DRAINAGE INFORMATION SHEET

PROJECT TITLE: Prairie Hills Apartments ZONE ATLAS/DRNG. FILE #: J22/D36

RE: CERTIFICATION FOR PRAIRIE HILLS APARTMENTS (J-22/D36)
CERTIFICATION STATEMENT DATED APRIL 2, 1986

RE: DRAINAGE COMPLAINT FROM THE QUAIL RIDGE SUBDIVISION
ALBUQUERQUE, NEW MEXICO (J-22/D36)

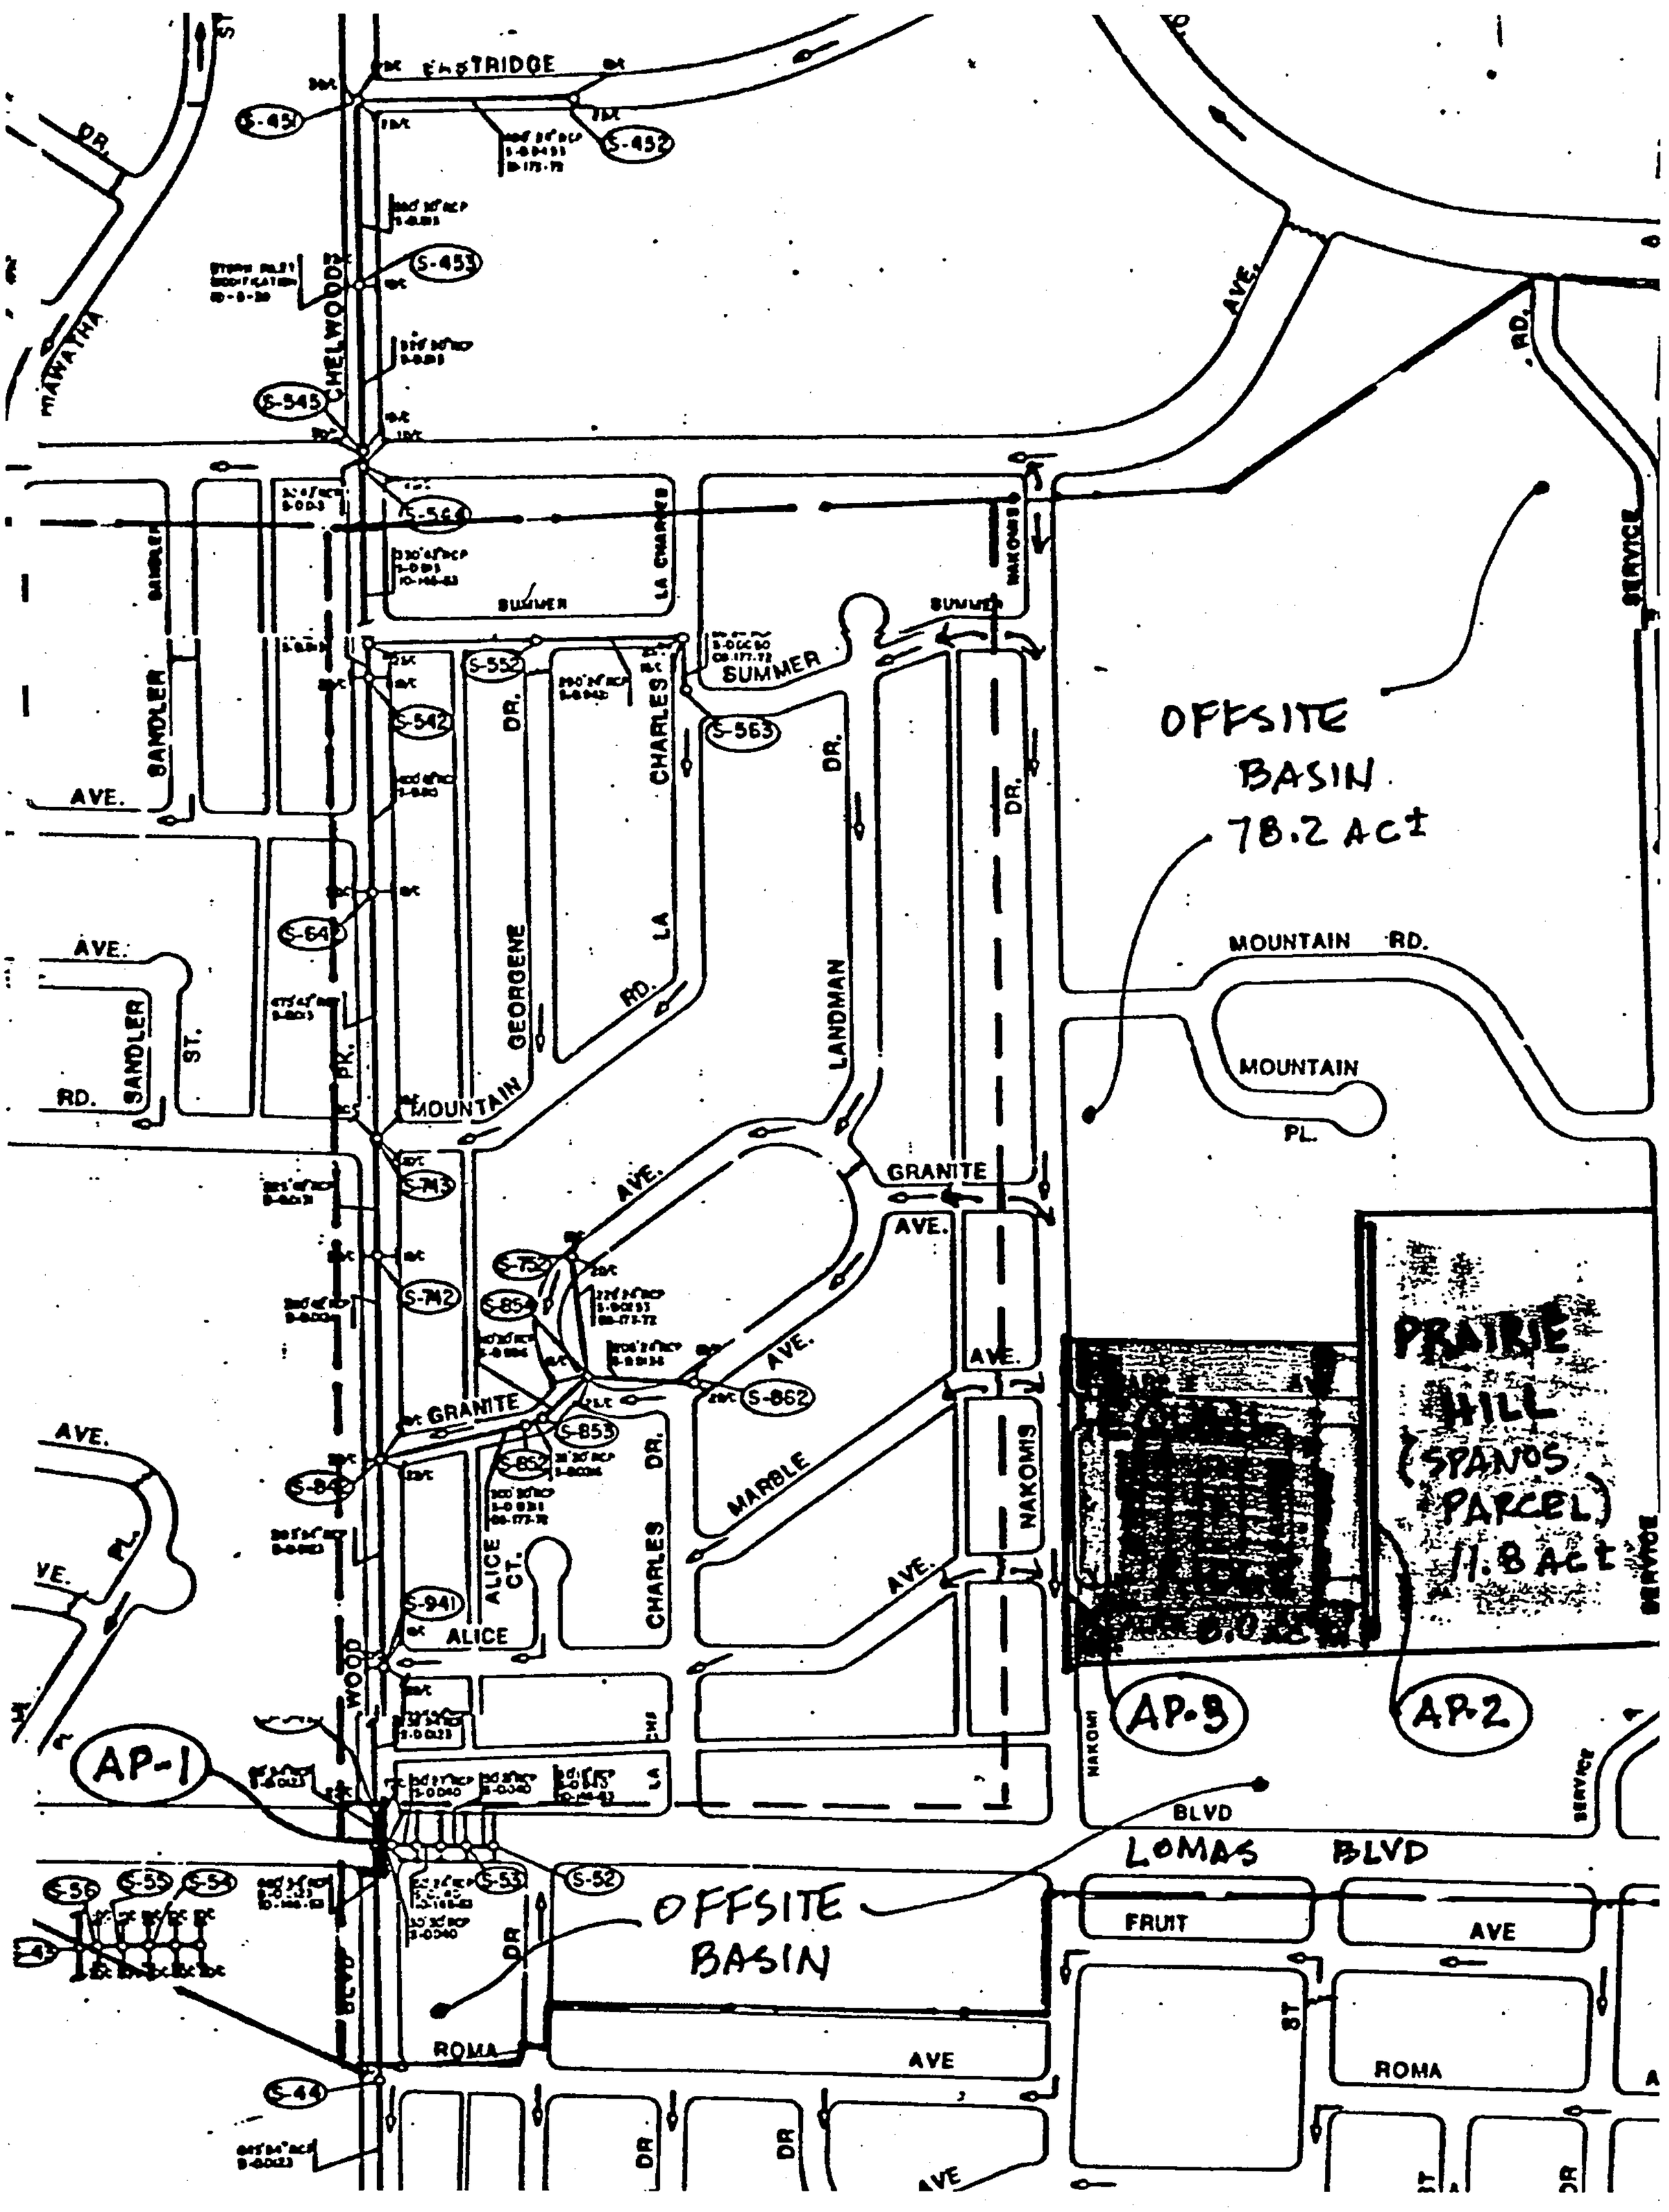
In response to your questions regarding the total drainage area and why the area bounded by Lomas, Constitution, Chelwood and Nakomis is not considered a part of the sub-basin under study, I have the following comments:

This drainage area does drain into the storm sewer system in question, however, it does so through numerous inlets upstream from analysis point No. 1. The capacity of the mainline in Chelwood is stated in the Albuquerque Master Drainage Study. The point made in the off-site analysis is that the Albuquerque Master Drainage Study failed to consider the bank of inlets located on Lomas, just east of Chelwood. This bank of inlets is the only relief for the sub-basin understudy. By analysis of these inlets and connecter pipe, the calculations demonstrate that this system of inlets has a capacity of 82 CFS. Considering a estimated Q10 = 136 CFS, future development in this area should be required to retain storm water. This retention should be considered temporary, until system "314-03D" is constructed.

POND 'B' OUTFALL SECTION K-K

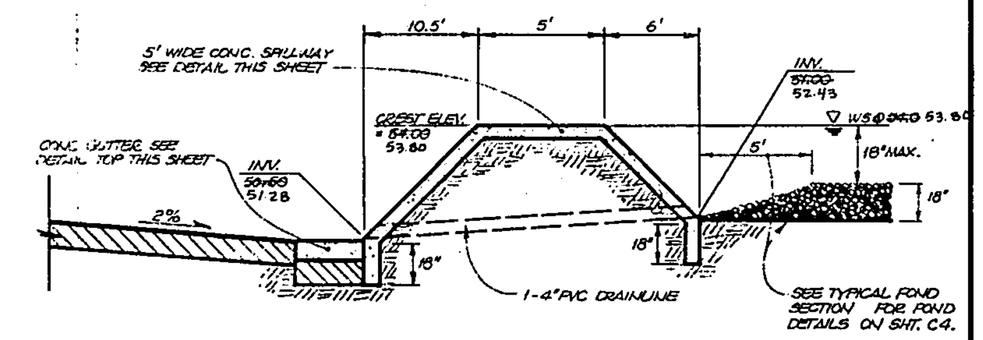
A drainage complaint was filed with our office on July 12, 1988 regarding overflow from Pond "B" which flows entered Lots 23 and 24 of the Quail Ridge Subdivision causing a garden wall to fail.

A subsequent field inspection and a topographic survey was conducted by the City's Survey Section, which revealed a grade deviation from the approved as-built certification provided by your consultant (Espey, Huston & Associates, Inc.). In particular, the elevation of the berm adjacent to Lots 23 and 24 is approximately .2 feet lower than the overflow elevation which resulted in the storm runoff exiting Pond "B" and collapsing a garden wall adjacent to Lots 23 and 24.

COMPLAINT: Pond B overflows to west and floods houses to west. Spillway may be higher than top of west berm or else blocked. Please survey and compare to "As-Builts".

INVESTIGATION — CAUSE: RUNOFF FROM PRAIRIE HILLS POND OVERTOPPING WEST BERM & RUNNING INTO 1012-1016 PAWNEE BACKYARDS. WALL @ 1012 HAS COLLAPSED, PONDS HAVE INSUFFICIENT CAPACITY

Action taken: Survey done on Pond "B" survey shows that the berm within certain places is below the spillway elevation. Letter is being sent to Engineer who certified the drainage concept. Also to owner A.G. Spanos

The maintenance of the berm is the responsibility of the owner, hence we are requesting that you make the necessary corrections as soon as possible to eliminate a recurrence of a similar problem.
